**Re:**           **Second Submission Review:**   1900 S Chambers Community Lot 1 - Site Plan Amendment Amdt.  
                  **Application Number:**         DA-2105-01  
                  **Case Numbers:**             2018-6020-03

Please use this cover letter as a guide for the Second Submittal of 1900 S Chambers Community Lot 1 – Site Plan Amendment. The following pages detail the response to your comments, and no major changes have occurred since the previous submittal. If you have any comments or concerns, please give call or email me. I may be reached at 817.687.8846 or [gbogdanoff@pnt-llc.com](mailto:gbogdanoff@pnt-llc.com).

Drainage Plan  
UPDATED.

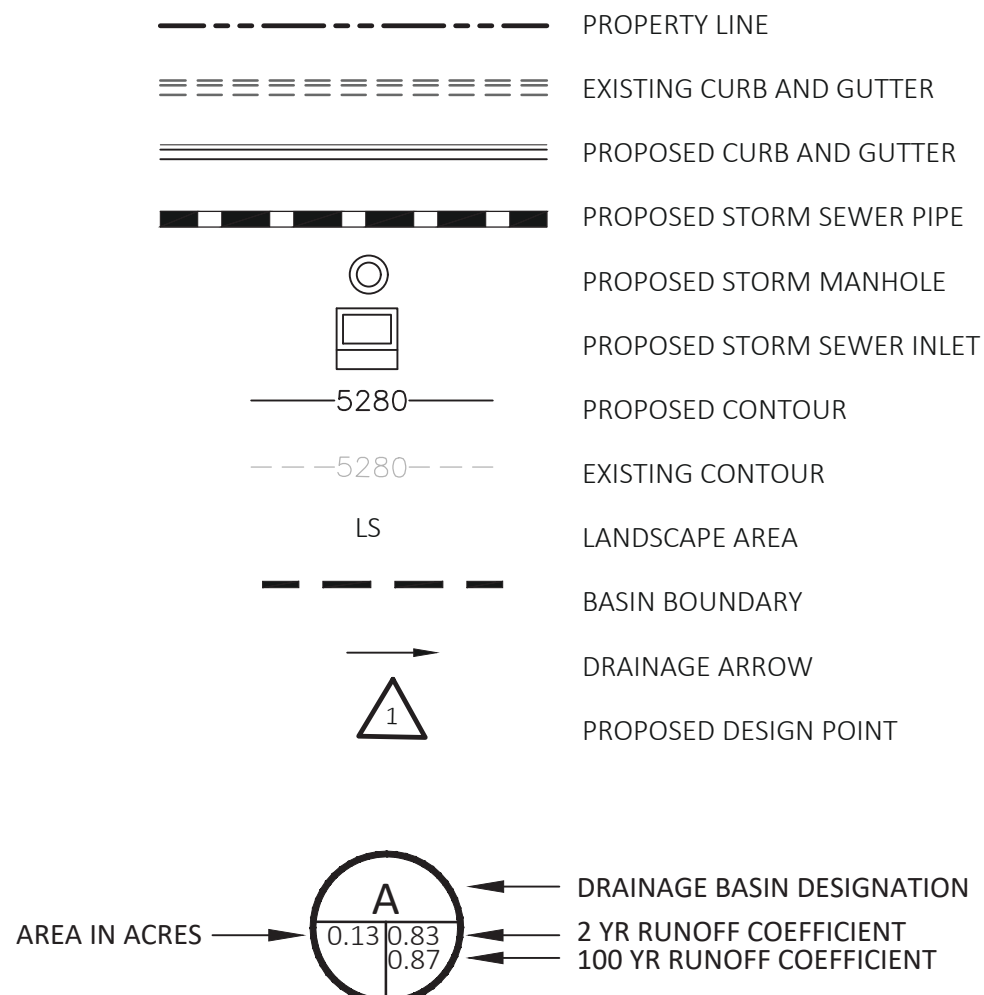
Please extend floodplain delineation to show overtopping extents over Chambers.

Reference report where this delineation came from. Show and label BFEs and cross sections on this drainage plan. If retaining wall location has changed at all since approval of 220098, updated HEC-RAS analysis required to be provided in Final Drainage Report. Otherwise, please include previously approved HEC-RAS analysis in the appendix to this PDR.

UPDATED THE FLOODPLAIN MAX ELEVATION, WHICH DOES NOT OVERTOP THE ROAD.

ADDED CHANNEL'S REPORT TO THE APPENDIX OF THIS DRAINAGE REPORT.
